Attachment E

Submissions

Subject: Submission - D/2023/1036 - 87 Lower Fort Street MILLERS POINT NSW 2000 - Attention Marie Burge

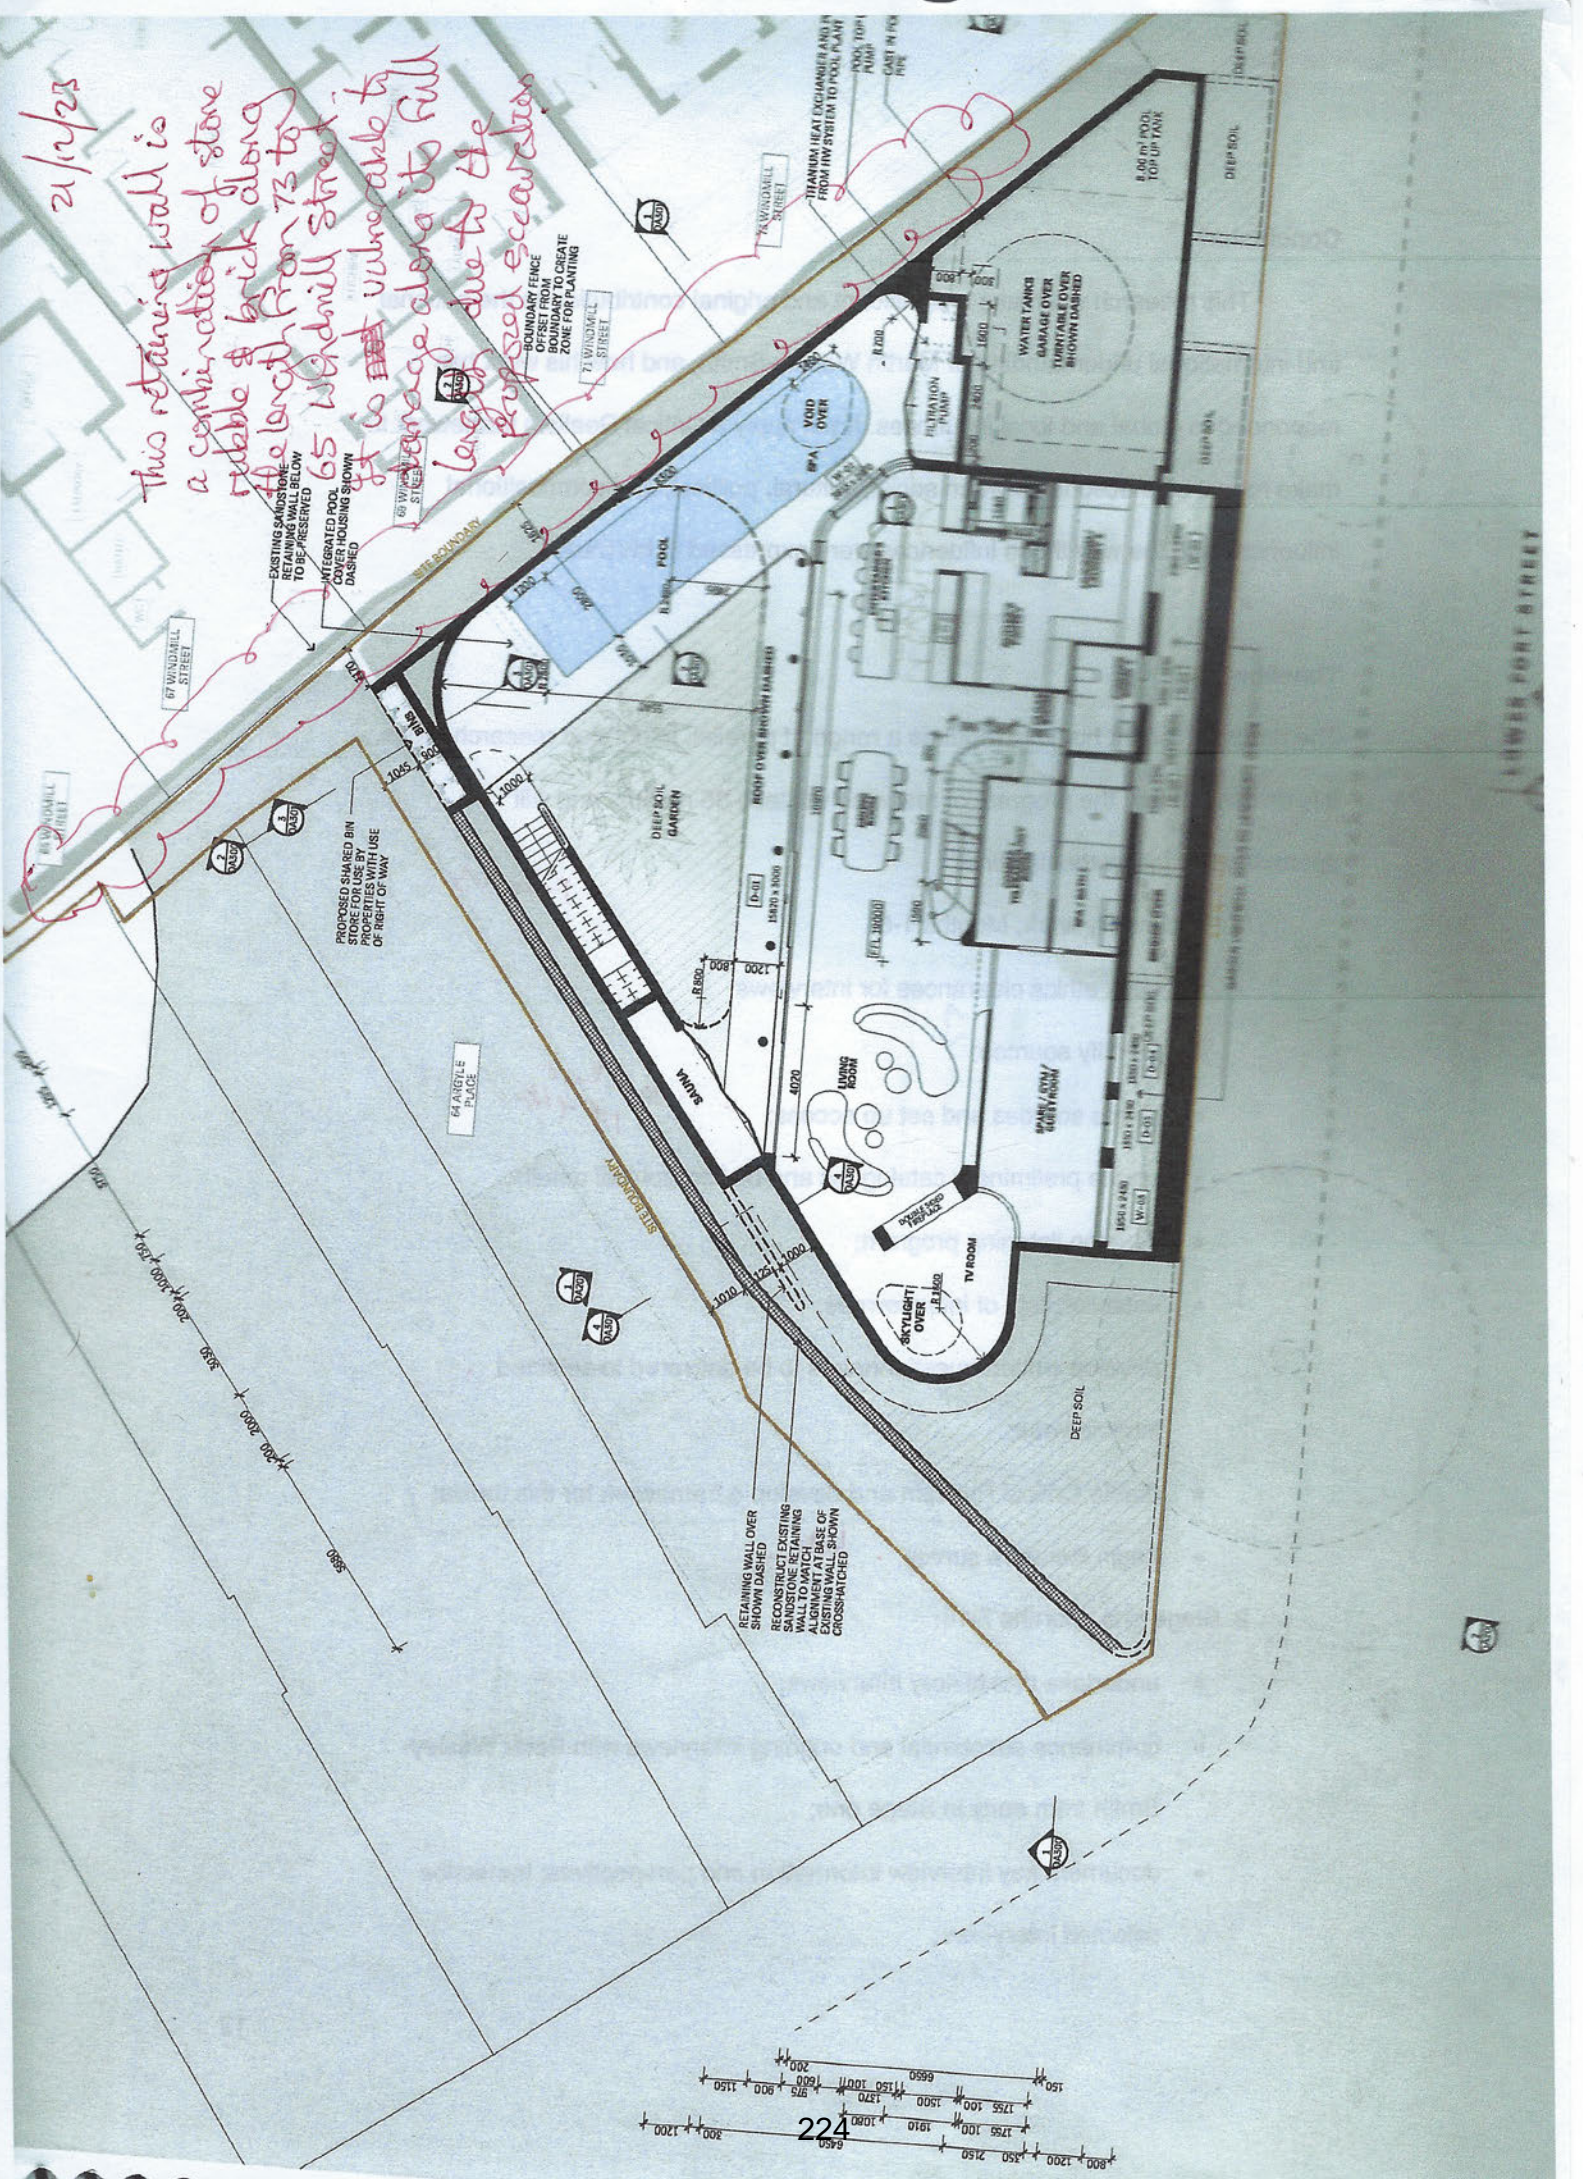
This retaining wall is a combination of stone rubble & brick along the length from 73 to 65 Werdmill Street. It is vulnerable to damage along its full length due to the proposed excavation.

69 WINDMILL
69 WINDMILL STREET

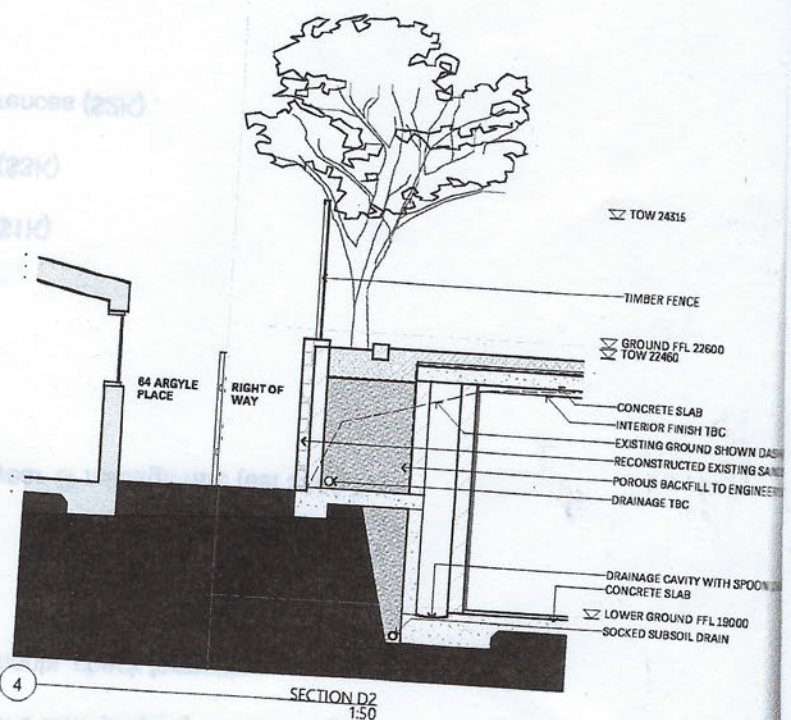
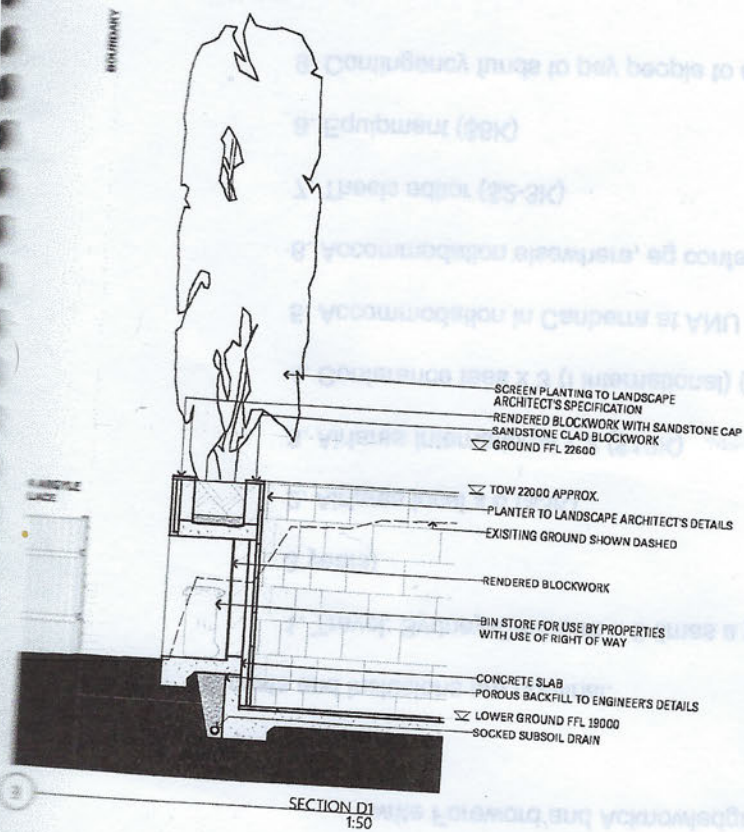
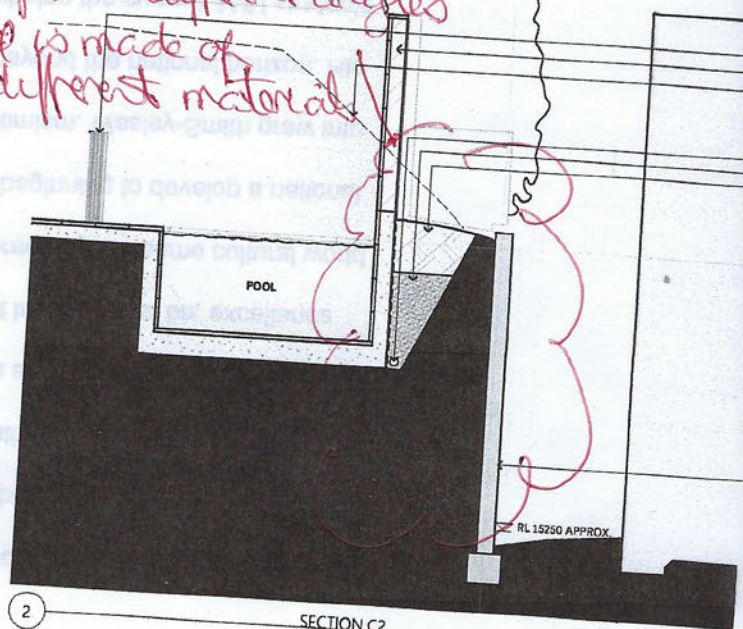
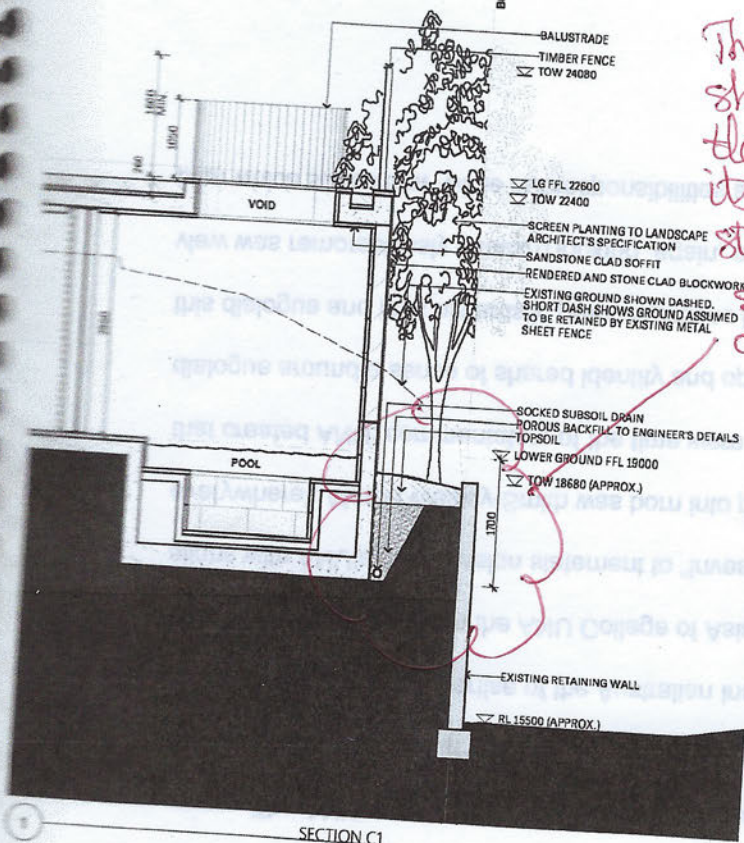
These sections do not show the true state of the retaining wall. Along its length its variously slopes at different angles & is made of different materials!
